# Caloundra South Town Centre VISUM Modelling Report

Prepared for Stockland  
April 2016

## Appendix D Response to SCRC and TMR Comments and Model Approval Emails

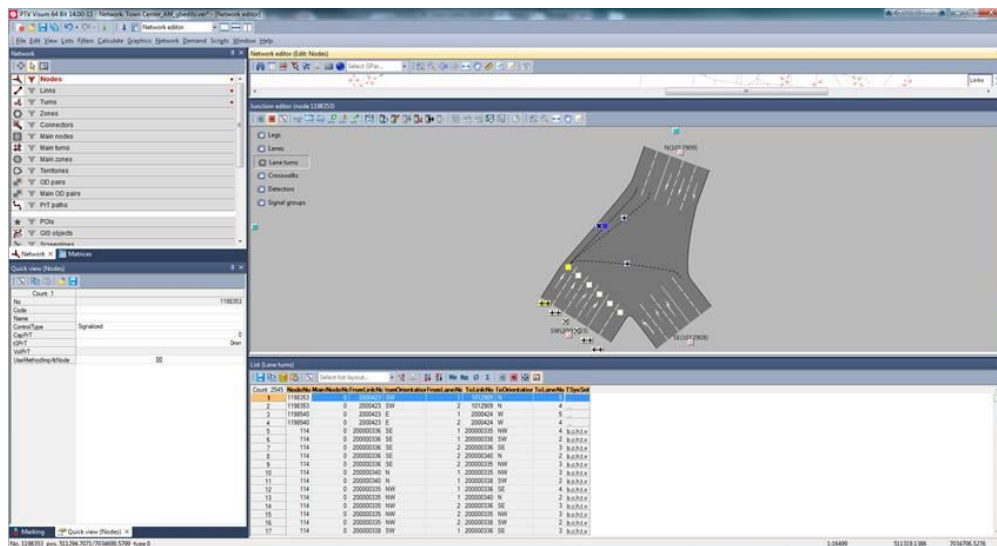
*Comment 1. It is unclear whether the model results provided to Council are from converged assignment. The model provided has both equilibrium and ICA assignment. The am equilibrium assignment does not converge after 20 iterations. Also, the ICA assignment has not converged after 100 runs. Convergence is required to ensure reliable, repeatable and appropriate results. Final comments are not possible until a converged model has been provided.*

Response 1. This comment has been addressed in the revised version of the Town Centre model.

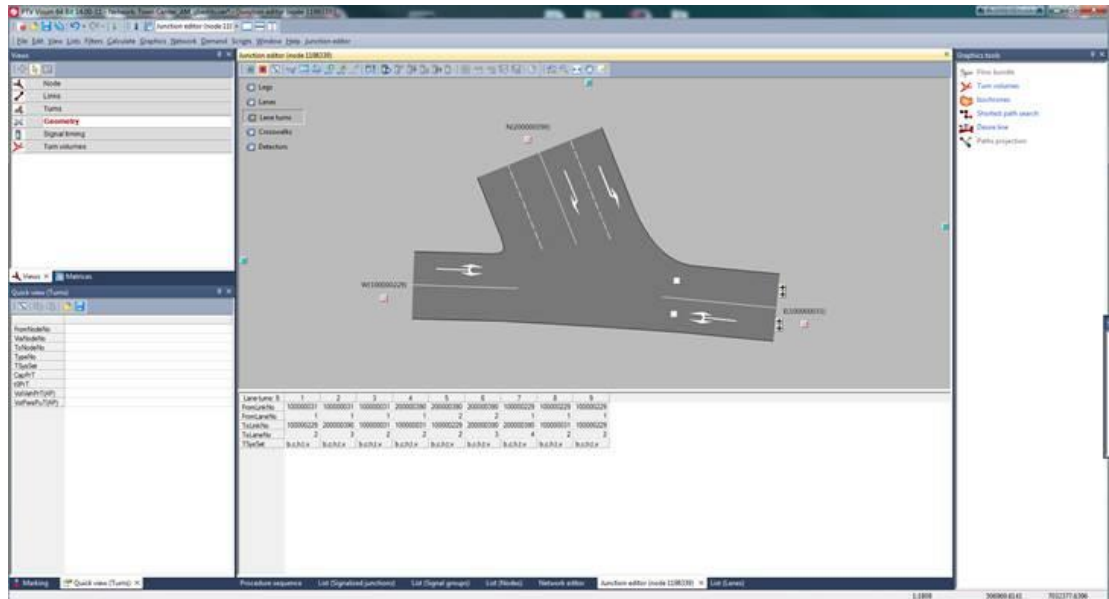
*Comment 4. There are numerous inconsistencies between links, turns, lanes and lane turns. It is unclear what effect if any these inconsistencies may have non-the-less they have been corrected in the attached am file;*

Response 4. This comment has been addressed in the revised version of the Town Centre model.

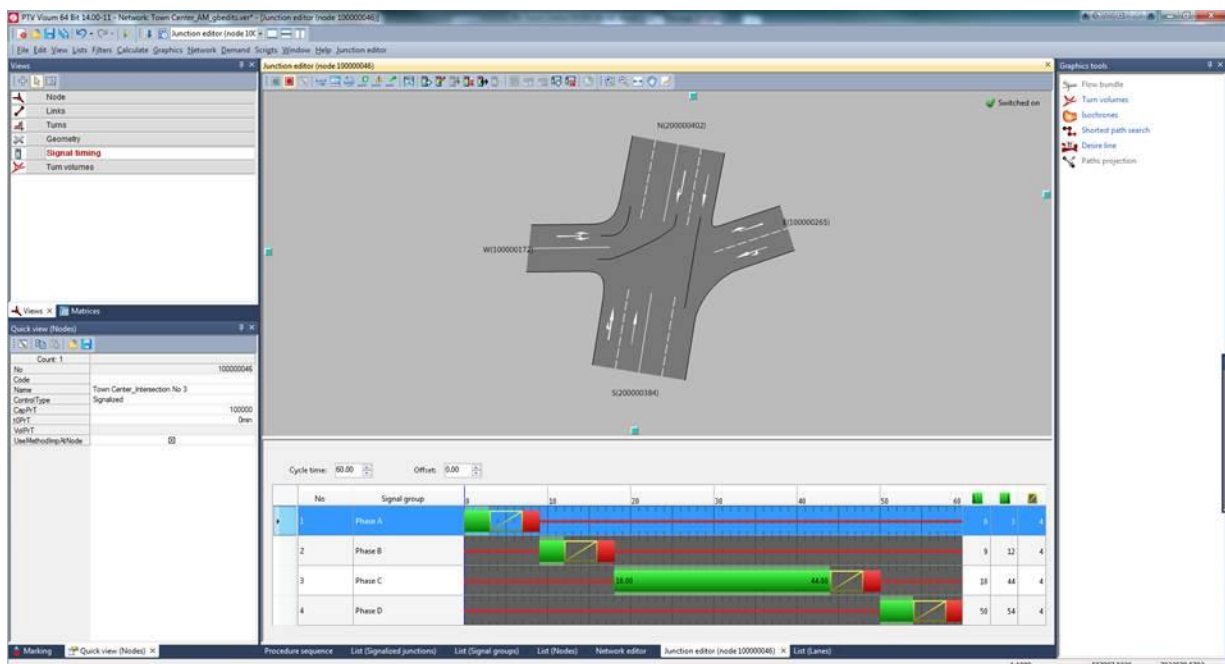
*Comment 5. In the town centre, some turns are inconsistent with node geometry (see attached). This may impact on turn priority and capacity. Network will export to vissim better if geometry is improved and medians and other intersection attributes are coded in visum;*

Response 5. This comment has been addressed in the revised version of the Town Centre model.

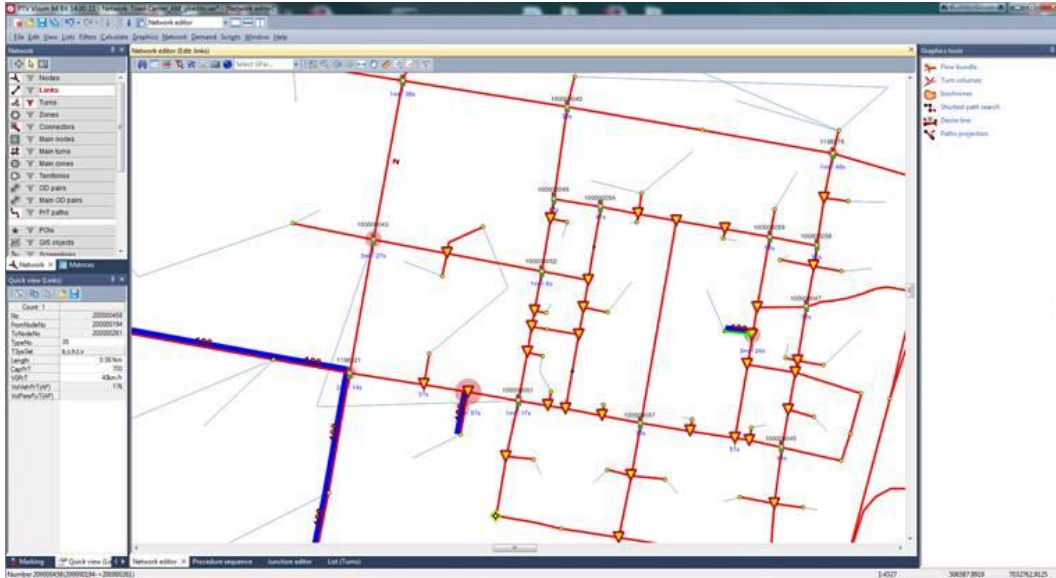
Comment 7. Several intersection do not appear to have been using ICA due to the issued raised above;

Response 7. This comment has been addressed in the revised version of the Town Centre model.

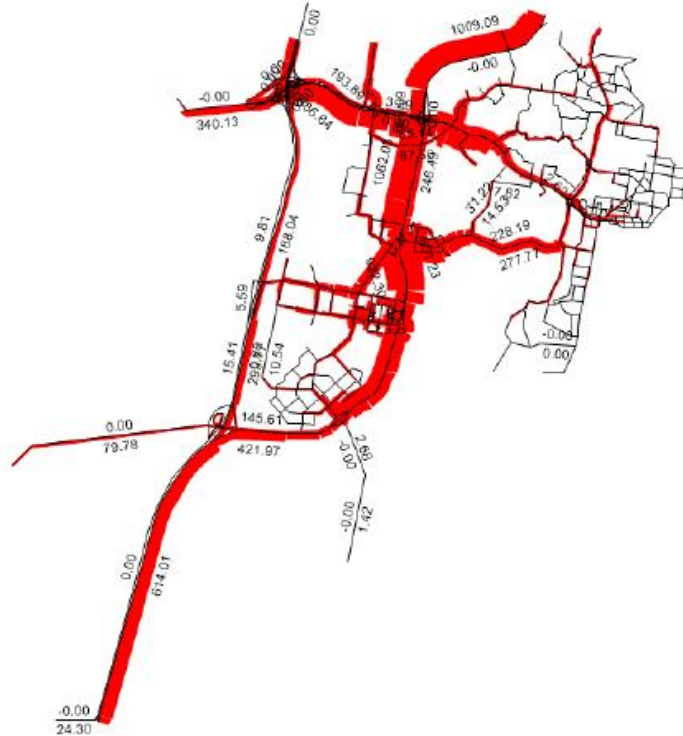
*Comment 1. There is a significant amount of latent demand within the model (see image below showing latent demand on links measured in vph).*

**Response 1.** Noted. Latent demand at the edge of the model is outside of the study area and reflects a pre-existing issue with the original model approved in 2014. These issues have been addressed partially with the assumption that they will be addressed separately as part of the model update due in 2017/2018.
